# **PRELIMINARY DRAINAGE PLAN PUD/SP 22-001**

## **HILLSIDE AT LORSON RANCH**

**JANUARY, 2022  
REVISED APRIL, 2022**

POND G  
WQ POND  
OUTLET STRUCTURE DETAILS

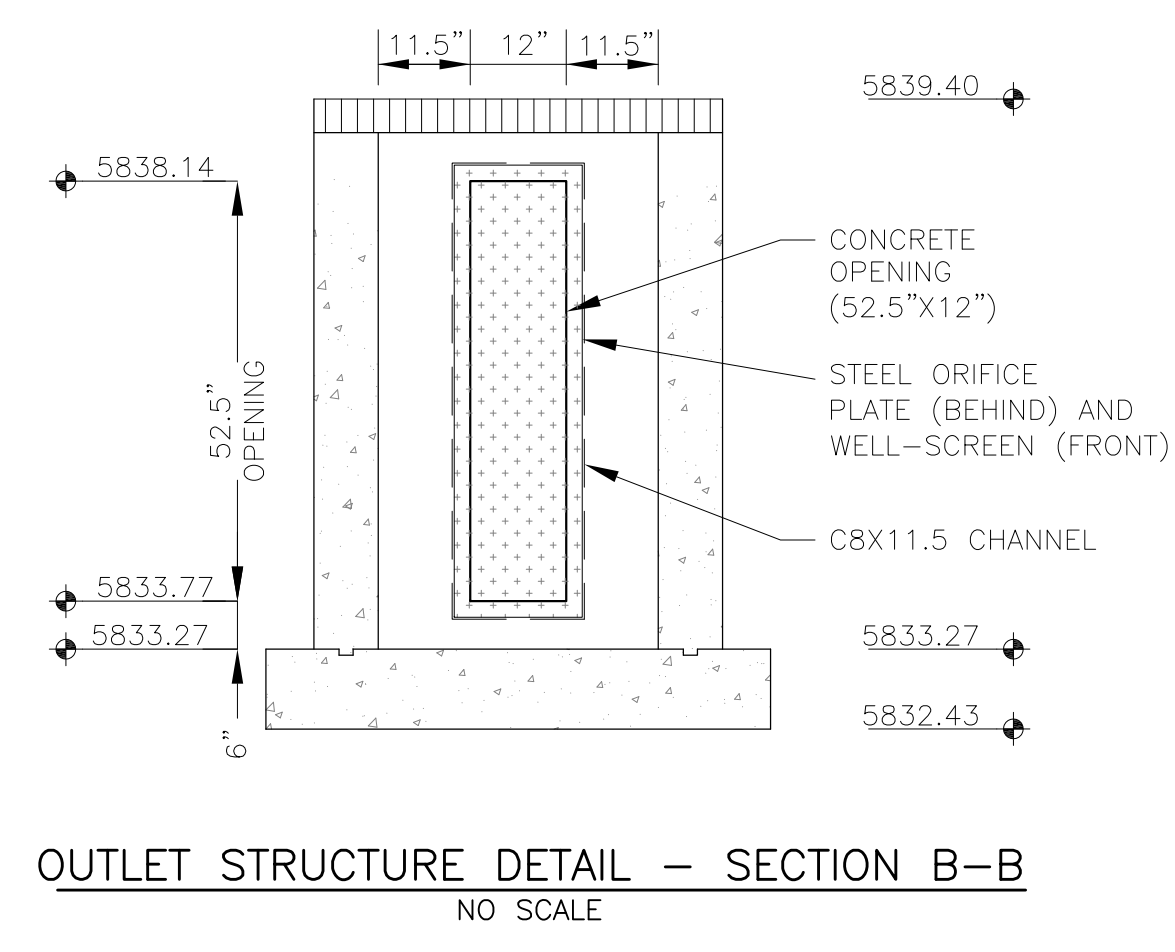
Use updated drawings

**DEVELOPED CONDITIONS**  
**HILLSIDE AT LORSON RANCH**  
 X

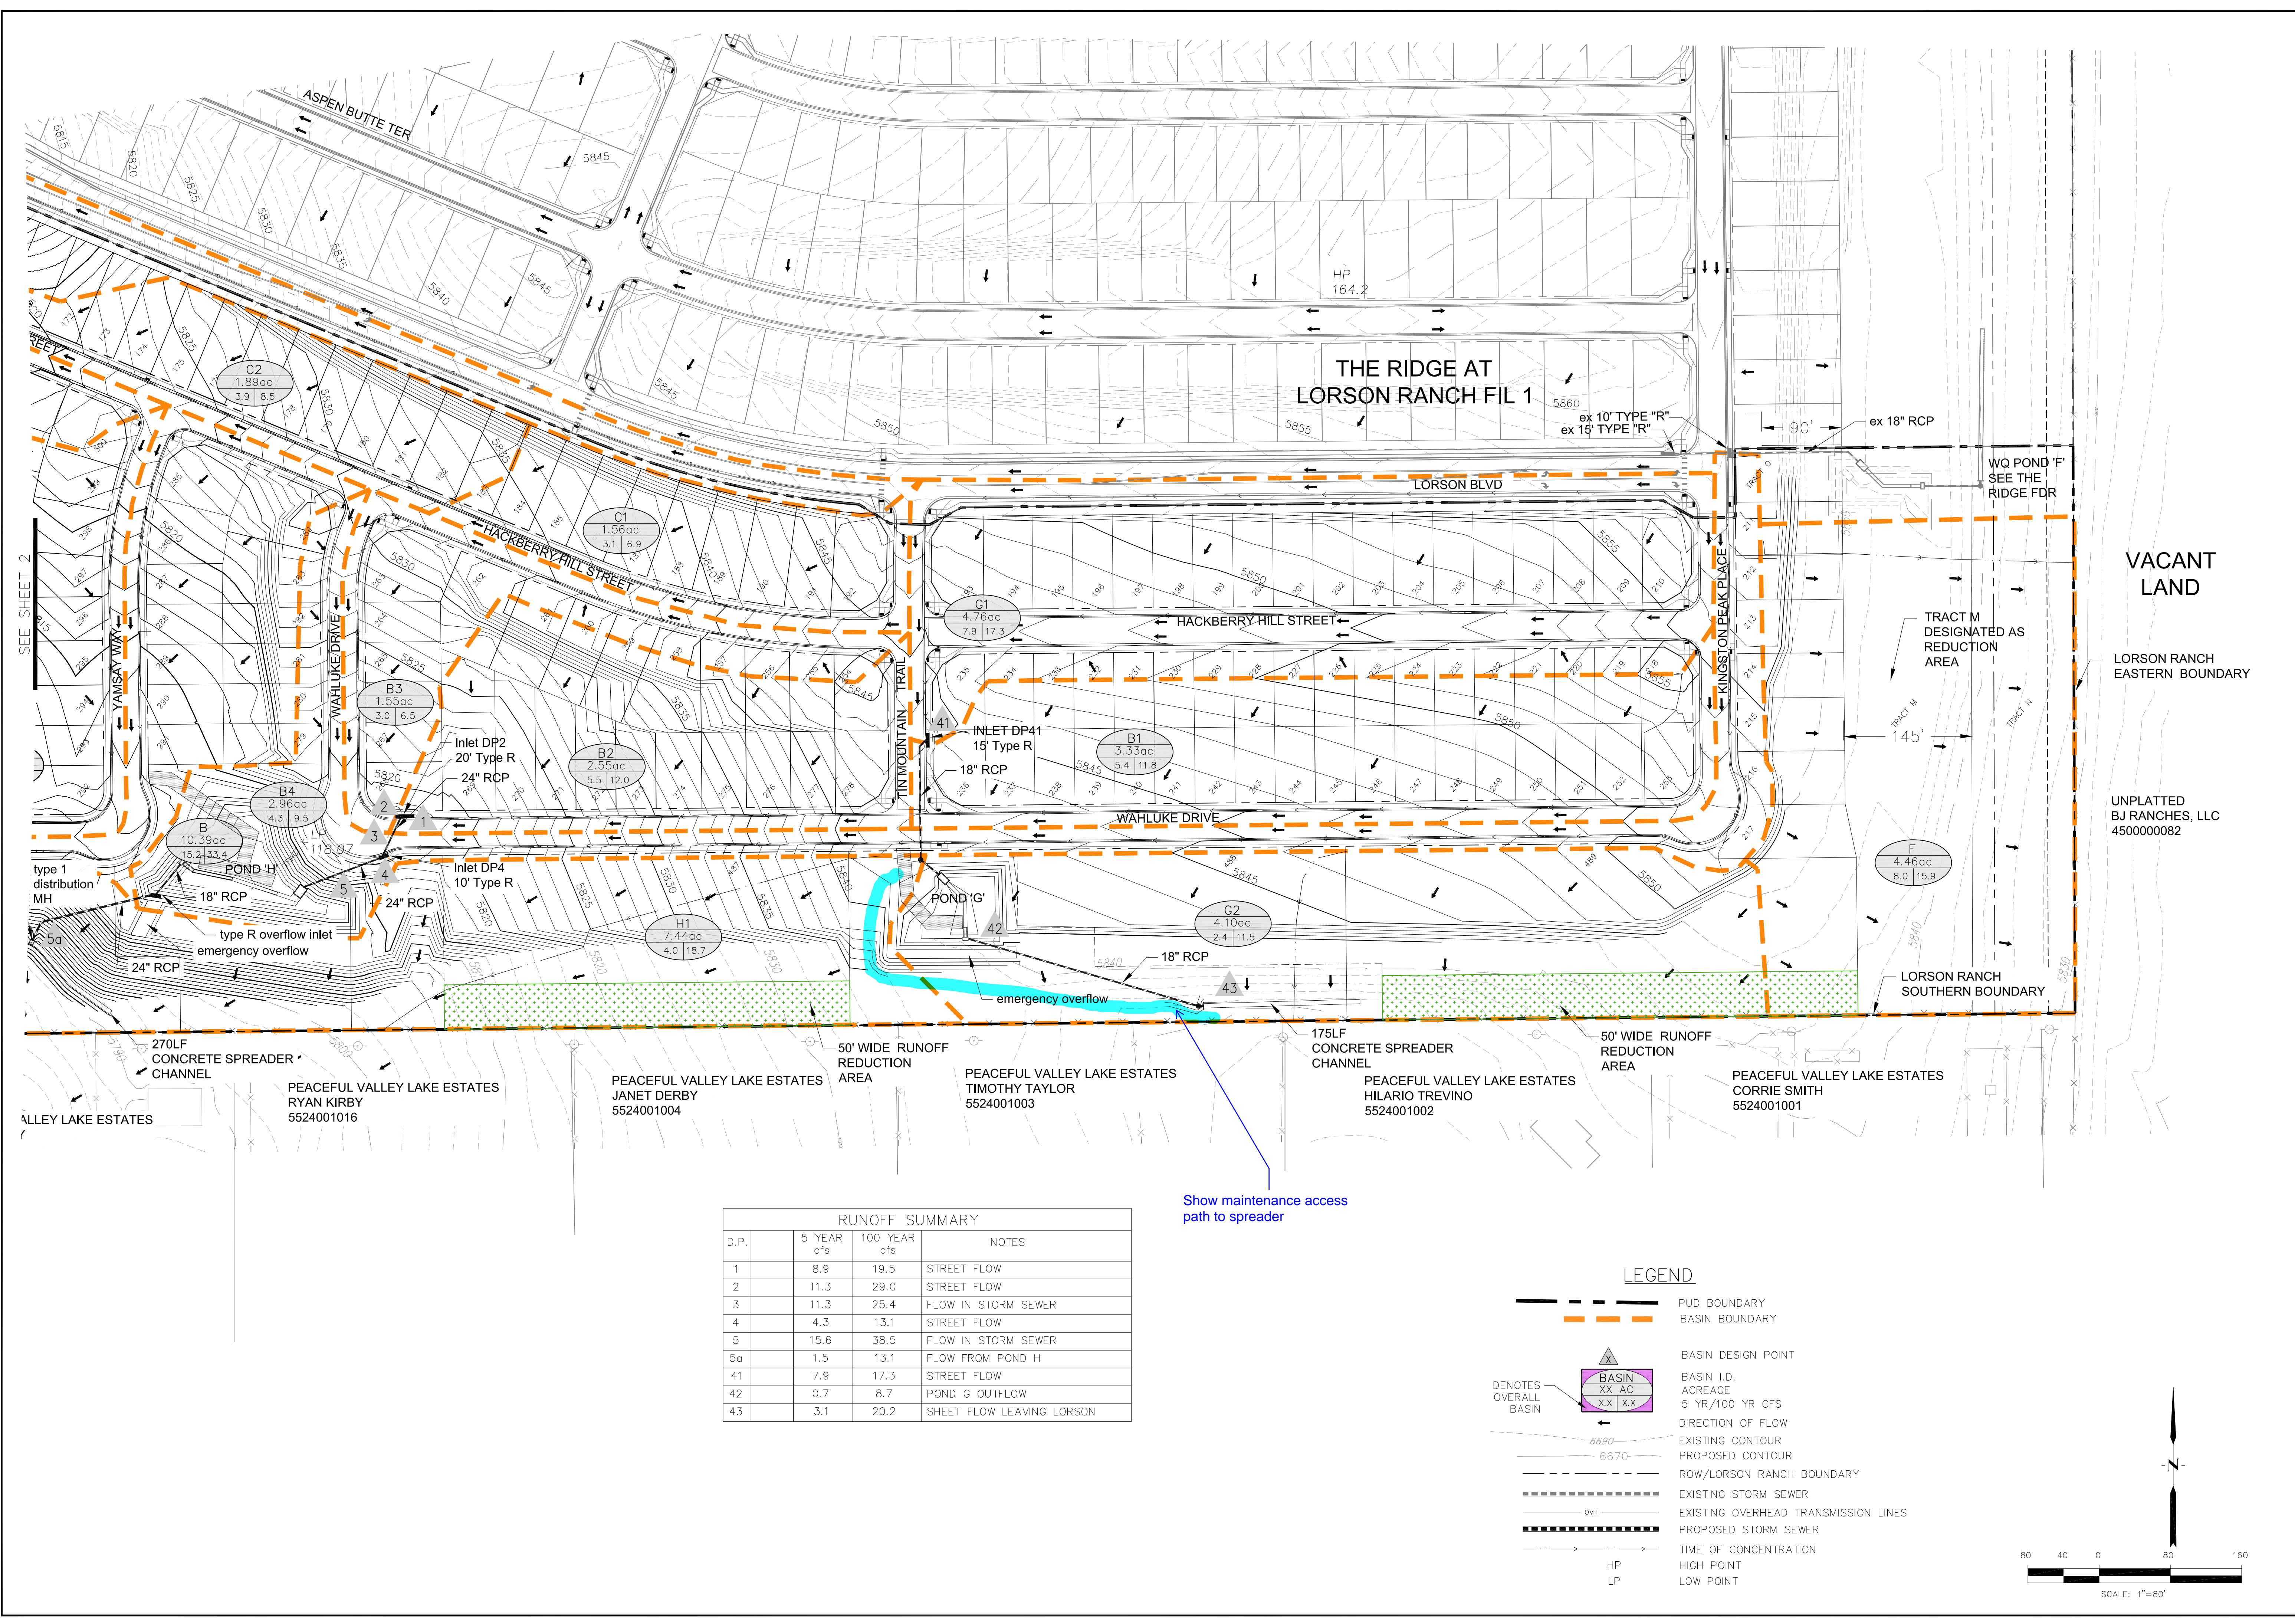
Show maintenance access path to spreader

Show maintenance access path to spreader
